TRANSPORT IMPACT ASSESSMENT

PROPOSED MULTIPLE DWELLING DEVELOPMENT

19 – 21 ANNE AVENUE, BROADBEACH

This is an amended version of the report submitted as part of the Development Application and responds to matters raised by Council in their Information Request letter dated 1st April 2025.

FIGURE 4.10– B99 VEHICLE PATHS (CRITICAL CAR PARKING AND MANOEUVRES)

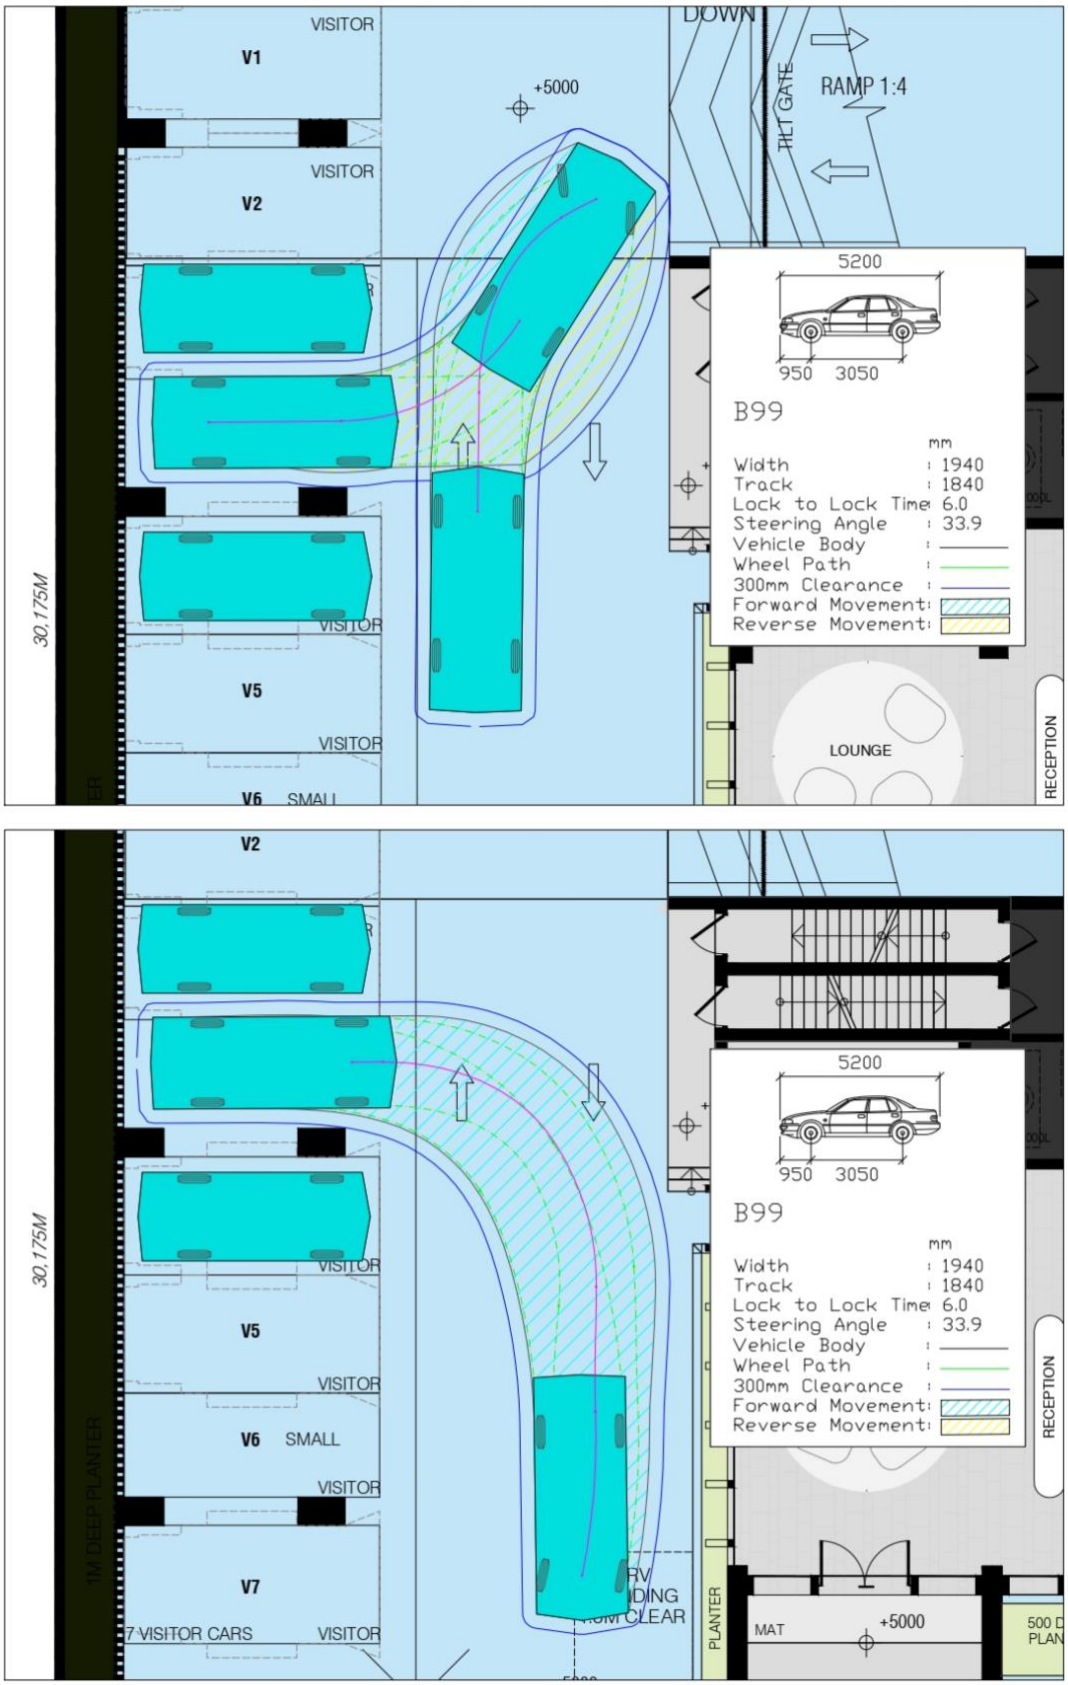
a. Submit a swept path demonstrating the ability for a B85 vehicle to turn around using the proposed turning bay located in the visitor car parking aisle (noting that the proposed turning area is impacted by columns and is only 2.3m wide, and is accessed from an aisle width of only 5.8m, instead of 6.1m).
   Note: a compliant number of visitor car parking spaces must be maintained with any changes proposed to accommodate a compliant turn-around area.
b. Provide further information regarding the intended function of the porte cochere and drop-off area.

k. Demonstrate a compliant width for the visitor car parking aisle (width of 6.1m required, between edge of parking spaces and vertical obstructions located opposite). Widths as low as 5.75m are currently shown.

a. Swept paths provided in Figure 4.10 confirm that a B85 vehicle can turn around using the turning bay located in the visitor parking aisle.
b. The drop-off area has been removed from the proposed plan of development.

k. As shown in Figure 4.10, the proposed parking aisle width of 5.8 metres allows adequate manoeuvring space for B99 vehicles in accordance with AS2890.1 requirements, particularly given the minimal usage and short-term nature of these bays.

FIGURE 5.5 – B99 VEHICLE PATHS CIRCULATING (BASEMENT LEVEL)

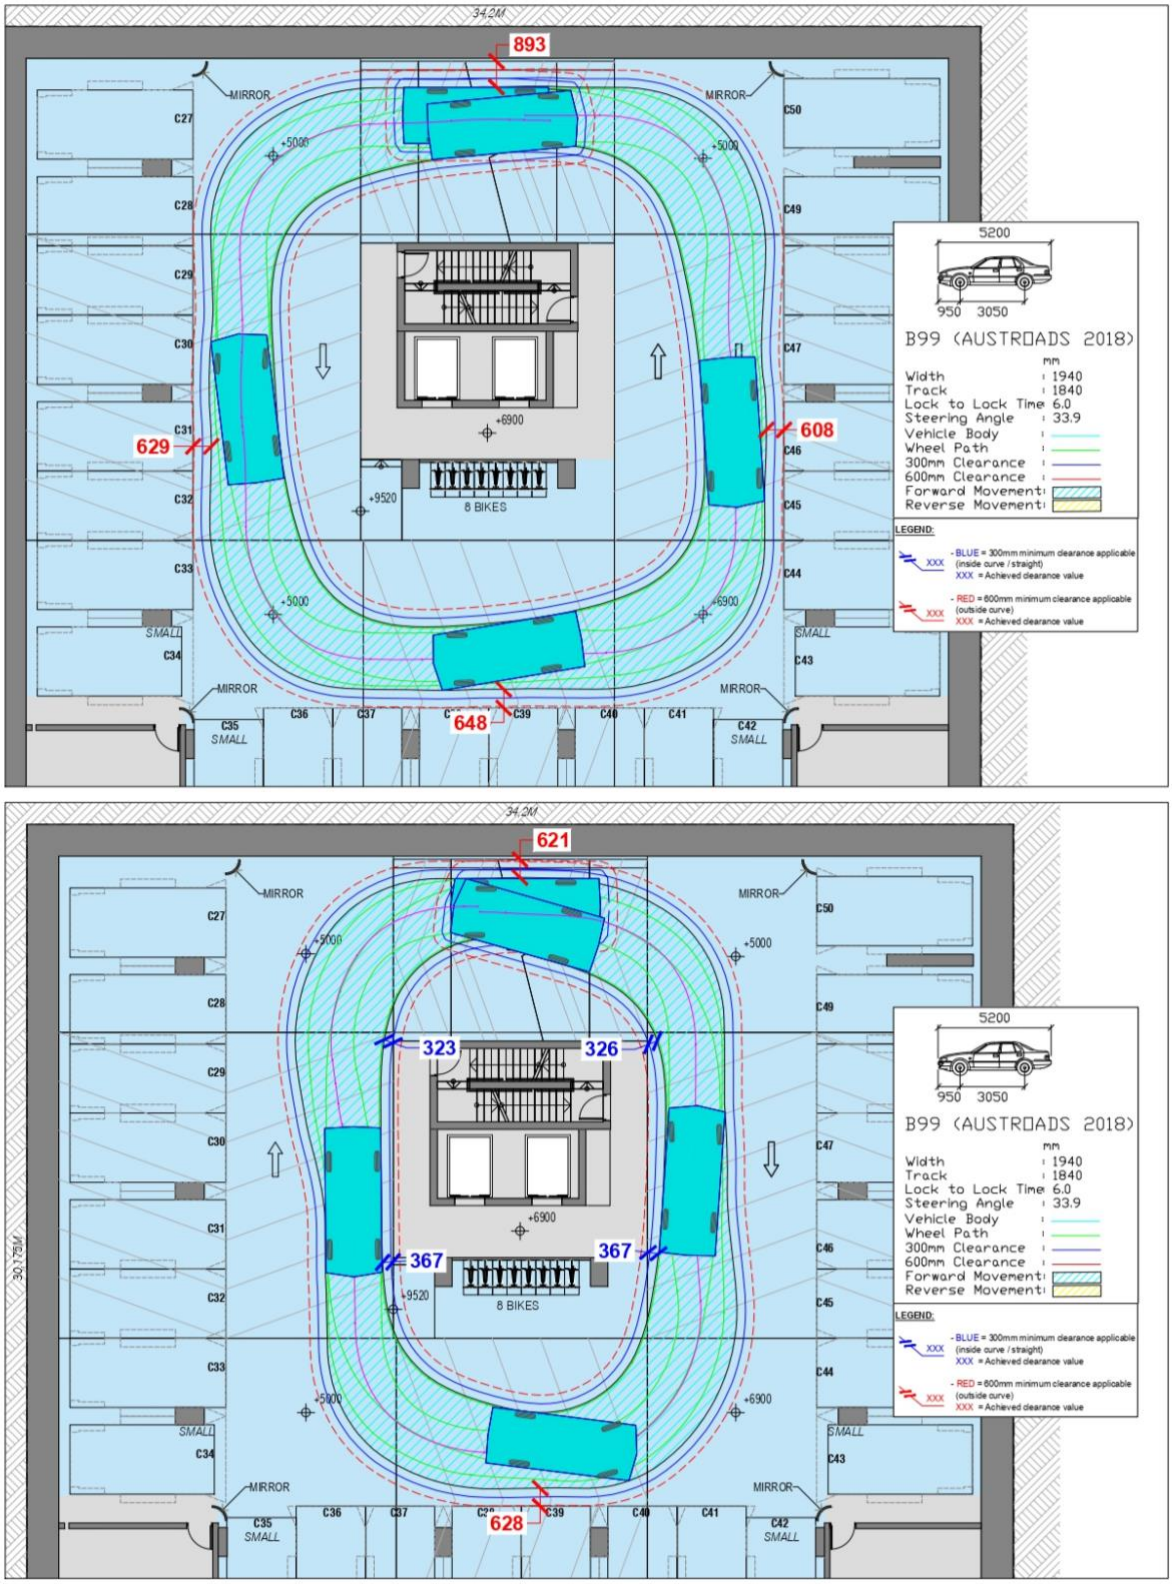
h. Swept paths are requested to be submitted demonstrating vehicle circulation within basement levels, with any need for management of opposing vehicle movements clearly demonstrated, and measures reflected on development drawings (note - swept paths have only been provided for circulation in podium levels).
Note - if compliant passing provision cannot be demonstrated within basement levels, and all passing is required to occur at ground level, sufficient queuing provision must be demonstrated (95th percentile vehicle queue).

h. Swept paths showing vehicle circulation within the basement are now provided in Figure 5.5. As stated in response to Item 5(b), the western driveway provides provision for more than three cars to queue before the ramp entry, and therefore meets the 95th percentile demand.

FIGURE 6.1 – PROPOSED LAYOUT AND DIMENSIONS OF VEHICLE CROSSOVERS

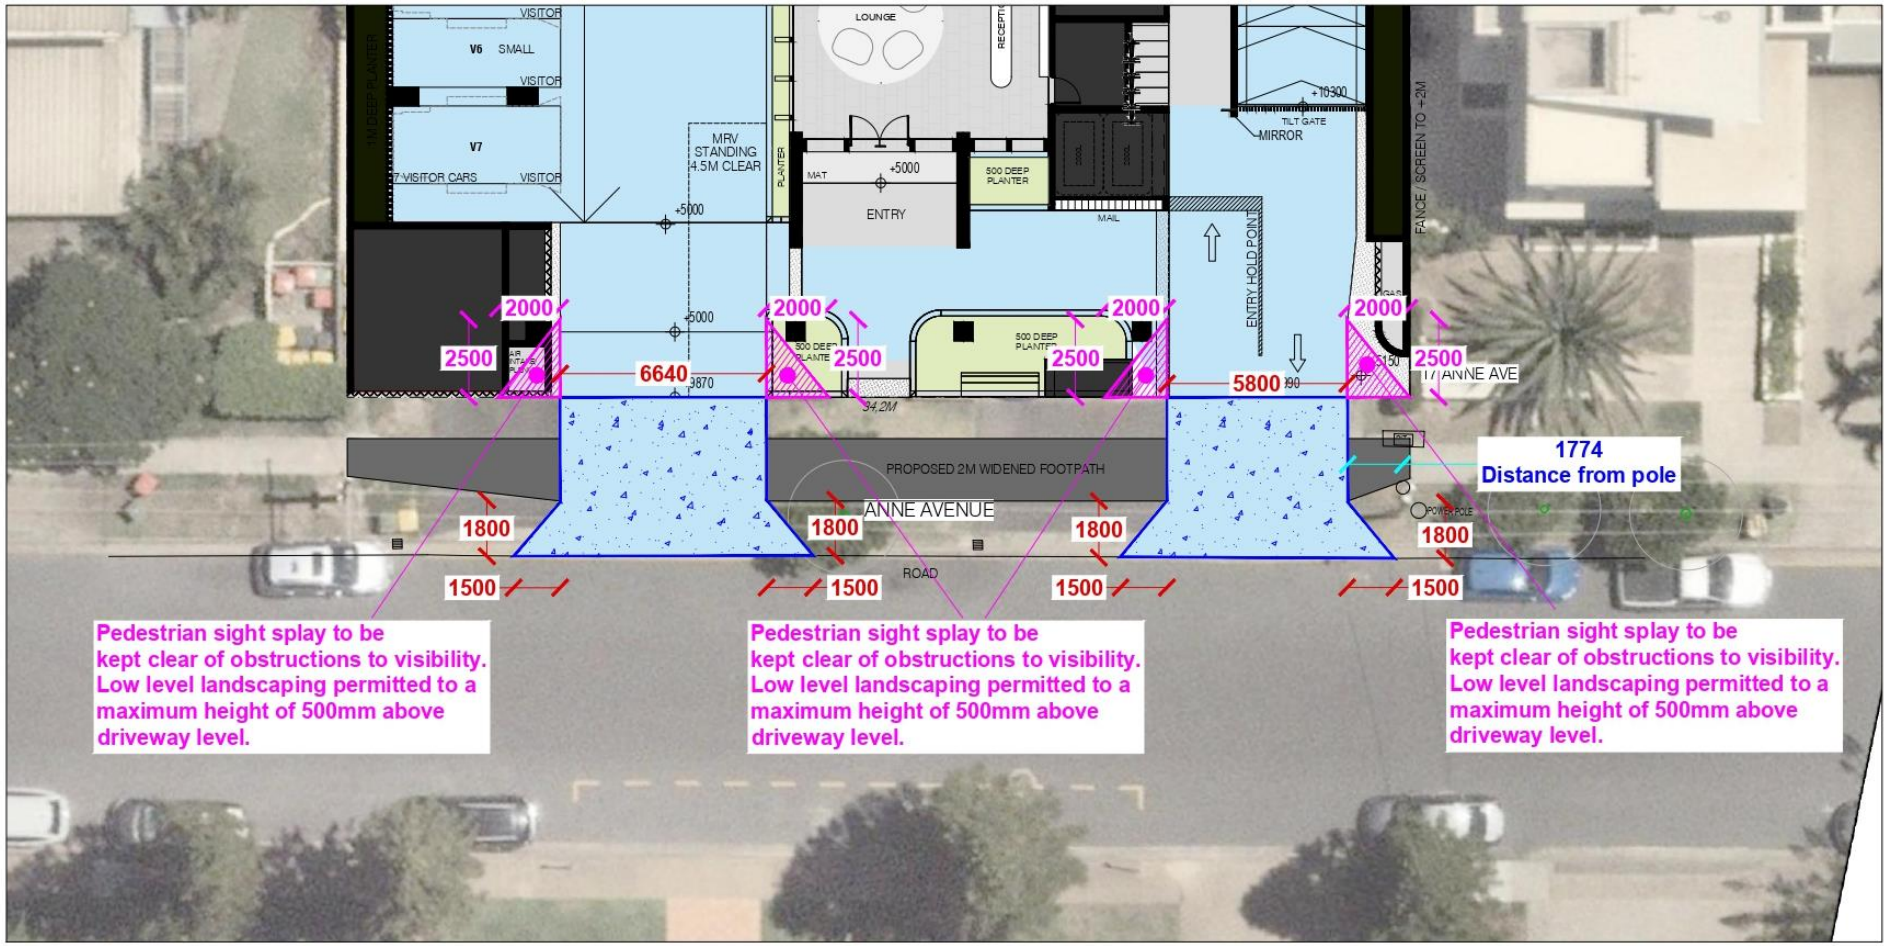
l. Identify the space located between visitor car parking spaces V5 and V6 as 'No parking'.
m. The vehicle crossover and driveway (western access) do not align; demonstrate how the driveway area leading to the crossover (on exit from the western driveway) will be treated to guide vehicles appropriately (and preserving the pedestrian sight triangle area).

l. This space is no longer proposed.
m. The alignment between the western driveway and crossover has been adjusted accordingly. Refer to Figure 6.1.
n. Pedestrian sight triangles are now shown consistently across all drawings, with appropriate annotation. Refer to Figure 6.1.

FIGURE 7.1 – MEDIUM RIGID VEHICLE (MRV) ACCESS AND MANOEUVRING

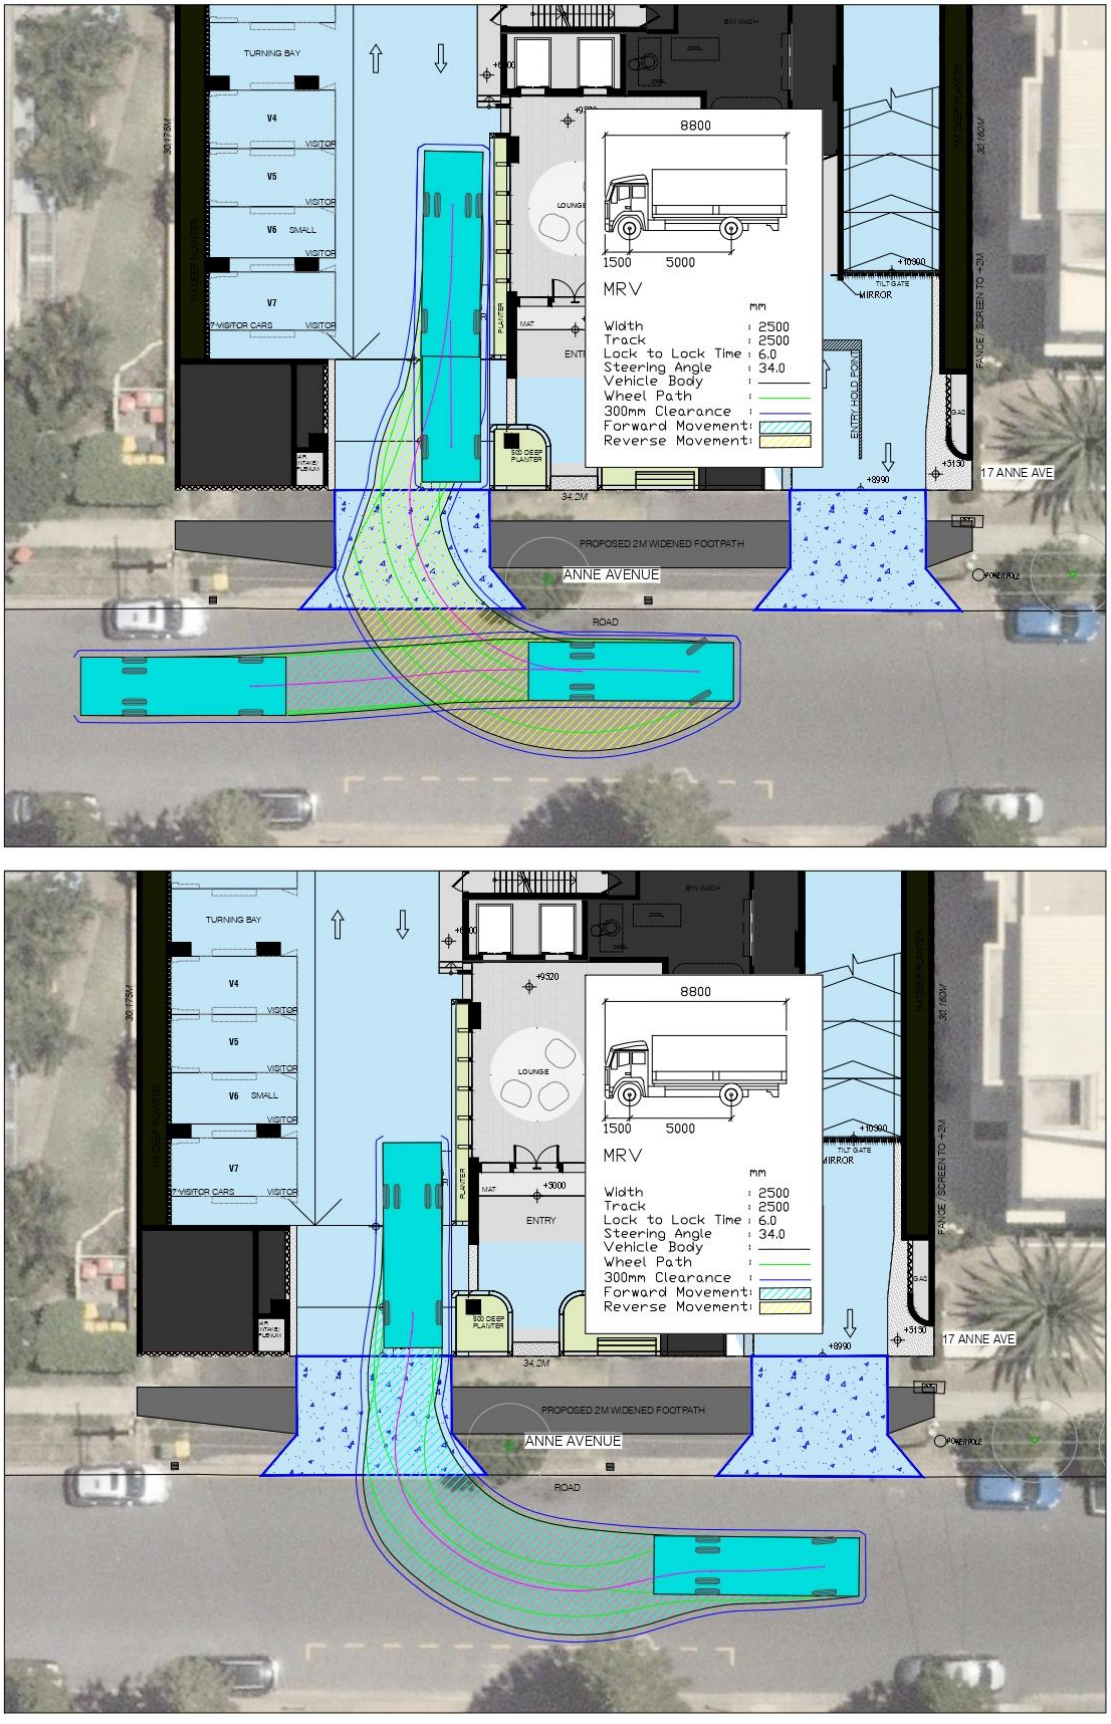
The proposed location of the 'standing area' for a Medium Rigid Vehicle (MRV) represents several conflicts with Transport code outcomes, as follows.

a. The proposed MRV 'standing area' conflicts with vehicle access to/from the site (does not allow two-way access for passenger vehicles to be maintained). An alternative location for MRV servicing (on-site) is requested to be demonstrated, supported by swept paths showing the ability for two-way passenger vehicle access to be maintained on-site (i.e. passing provision, at ground level) when an MRV is positioned in the 'standing area').

b. Swept paths showing access to/from the proposed MRV standing area show use of the 'turn from stop' function. Revised swept paths are requested to be submitted demonstrating access by an MRV to and from the standing area without using the 'turn from stop' function (and ensuring the vehicle position is maintained within the kerbside travel lane i.e. does not cross over the centre of Anne Avenue to enter or exit the site). Modification to the alignment of the vehicle crossover may be required, to align with the driveway (while ensuring that a compliant pedestrian sight triangle is maintained on the departure side of the western driveway).

c. It's unclear how far back the (minimum) 4.5m vertical clearance extends, from the front property boundary. Submit a drawing clearly depicting the length of driveway that accommodates compliant vertical clearance for an MRV.

d. The proposed MRV standing area is only 8.7m long; the standing area is requested to be 8.8m long (minimum).
e. The MRV standing area may be reduced to 2.5m wide (rather than 3.5m), as it is a standing area (rather than a dedicated service bay).

a. The proposed plan of development has been updated to relocate the Medium Rigid Vehicle (MRV) standing area. The removal of the former porte-cochère and widening of the driveway enables the MRV standing area to be positioned further toward the front boundary. As shown in Figure 5.2, a B99 passenger vehicle can safely circulate past a stationary MRV, with sufficient clearance.

b. Updated swept paths have been prepared for the revised MRV standing location (Figure 7.1). Anne Avenue functions as a local access street with no centreline marking. It is acceptable for occasional heavy vehicle movements to cross the centre of the road, as is common for other developments in the area.
   The vehicle crossover has been realigned with the driveway to support compliant entry and exit movements while maintaining a clear pedestrian sight triangle.

c. Refer to the architectural package for further details.
d. The MRV standing area has been extended to 8.8 metres in length.
e. The width of the MRV standing area has been reduced to 2.5 metres.
